NFPA 70 — May 2001 ROP — Copyright 2000, NFPA

(Log #1158n)

1-1 - (Entire Document): Accept

FIGURE 1

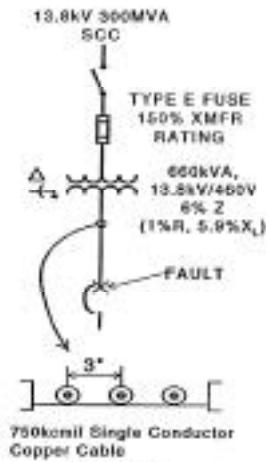
Figure 1 shows the fault current and conductor temperature rise calculations for both cases. Figure 2 shows the calculations for conductor impedance. In all cases the conductor temperature rise for the 100 ft length of cable of Case 1 is lower than the corresponding value for the 50 ft length in Case 2. The highest temperature rise of 41°C in Case 2 is still well within the worst case limits for modern cable insulations.

Figure 410-8 Closet storage space.

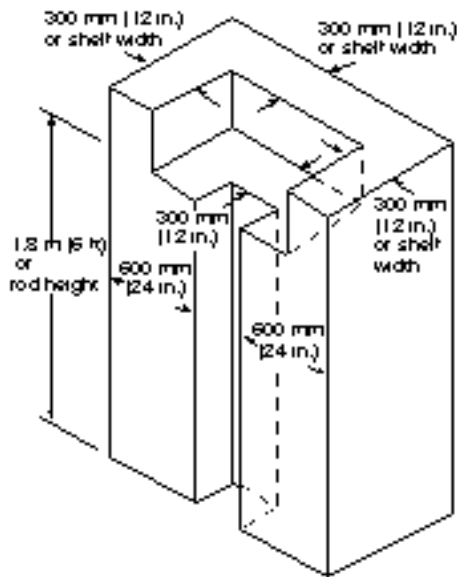
18-14 - (Figure 410-8): Accept in Principle
 SUBMITTER: Technical Correlating Committee National Electrical Code
 RECOMMENDATION: Revise Figure 410-8 as follows:

SUBSTANTIATION: The proposed revision is intended to comply with the NFPA No. 1M Manual of Style Section 4.1 with respect to the placement of units and values of measurement.
 PANEL ACTION: Accept in Principle.

Figure 505-89(b)(1) ~~505-10(b)(1)~~

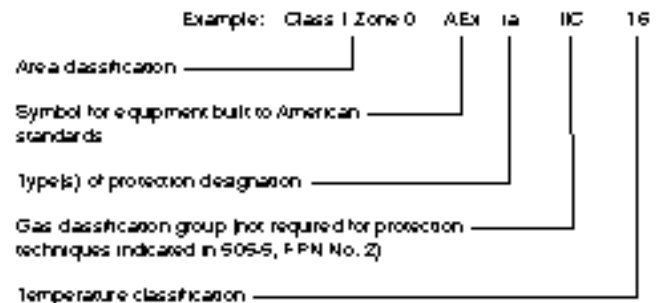
14- 357 - (Figure 505-10(b)(1)): Accept in Principle
SUBMITTER: Frederic P. Hartwell, Hartwell Electrical Services, Inc.
RECOMMENDATION: Rename this drawing "Figure 505-10(b)(2)".
SUBSTANTIATION: This is the subject of Section 505-10(b)(2) FPN No. 2. Due to a printing layout error in the first printing, it appears on a different page, resulting in widespread confusion. Although that is a printing error, NFPA staff, in my opinion, can be forgiven on this one since its subject is far more intimately connected with the second paragraph. If it were properly named by the panel, it probably would have been printed in its proper location. In fact, it might be titled "Figure 505-10(b)(2) FPN No. 2".
PANEL ACTION: Accept in Principle.
PANEL STATEMENT: The Figure will be correctly numbered in accordance with the editorial rewrite.
NUMBER OF PANEL MEMBERS ELIGIBLE TO VOTE: 14
VOTE ON PANEL ACTION:
AFFIRMATIVE: 12

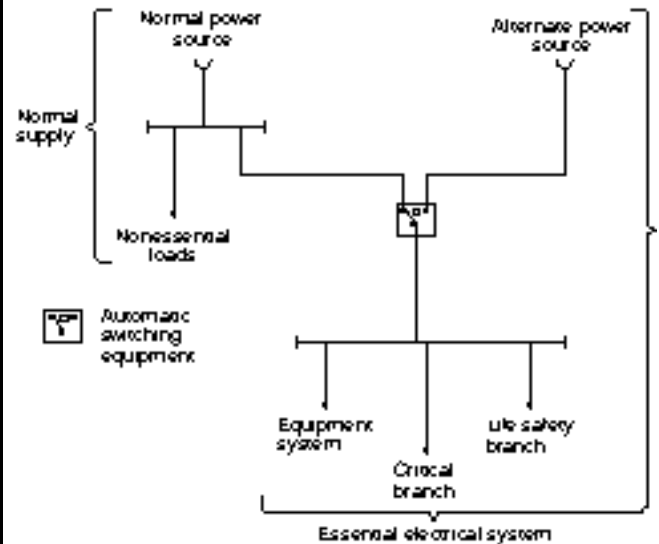
17- 31e - (Figure 517-30(c)): Accept

RECOMMENDATION: Renumber existing Figure 517-30(c) as FPN Figure No. 2. Revise the figure as shown:

Figure 517-30(c) Small electrical system — hospitals (single transfer switch).

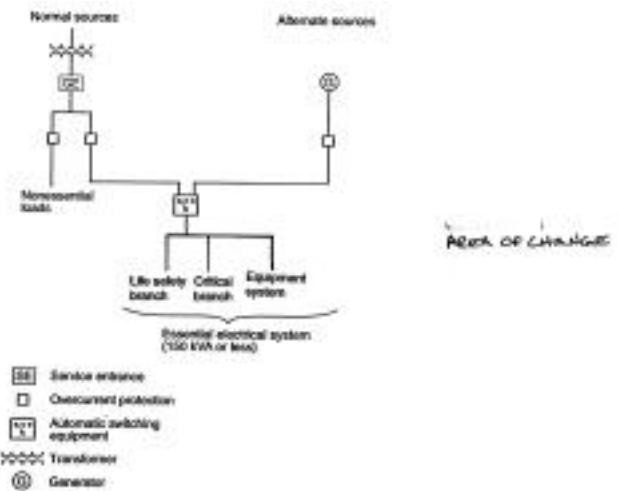
17- 32 - (Figure 517-30(c)): Accept in Principle

RECOMMENDATION: Revise figure as follows:

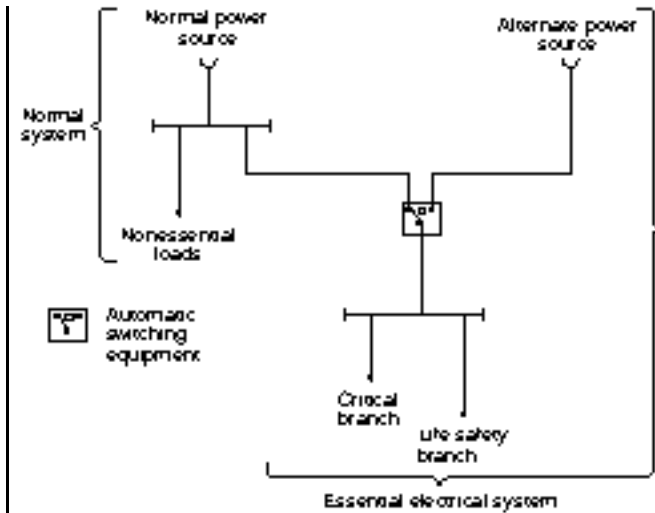
17- 45f - (Figure 517-41(c)): Accept

RECOMMENDATION: Renumber existing Figure 517-41(c) as FPN Figure No. 2.

Figure 517-41(c): Small electrical system — nursing homes and limited care facilities (single transfer switch).

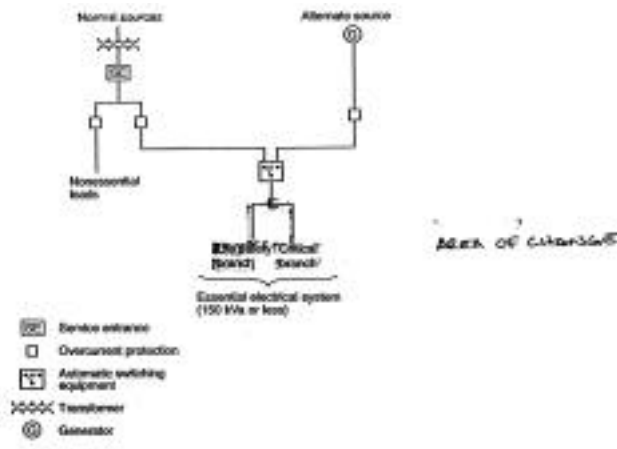
(Log #1826)

17- 46 - (Figure 517-41(c)): Accept in Principle
SUBMITTER: Bruce Reynolds, State of Washington
RECOMMENDATION: Revise figure as follows:

Figure 770-53 Cable substitution hierarchy.

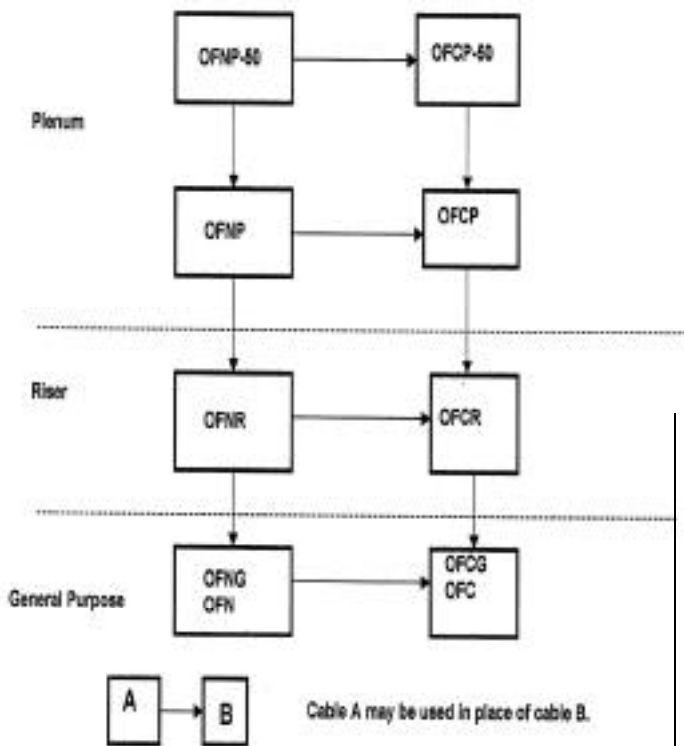
COMMENT ON AFFIRMATIVE:
 KAUFMAN: In addition to revising Table 770-53, Figure 770-53 should be revised in order to illustrate the changes in Table 770-53.

Figure 800-53. Cable Substitution Hierarchy

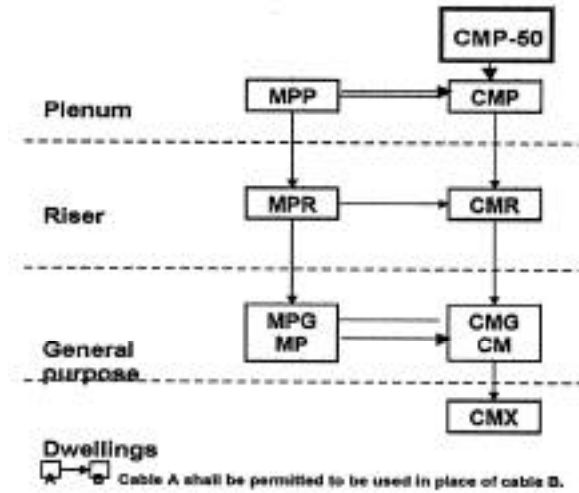
KAUFMAN: In addition to revising Table 800-53, Figure 800-53 should be revised in order to illustrate the changes in Table 800-53, furthermore Type CMP-50 should be added to Table 800-53 as a permitted substitute for Type CMP.

Figure 820-53. Cable Substitution Hierarchy

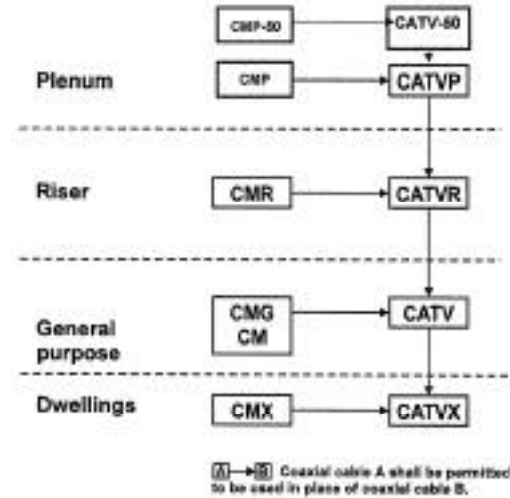
KAUFMAN: The recommendation and substantiation incorrectly refers to Table 820-50. This proposal deals with Table 820-53.

In addition to revising Table 820-53, Figure 820-53 should be revised in order to illustrate the changes in Table 800-53.
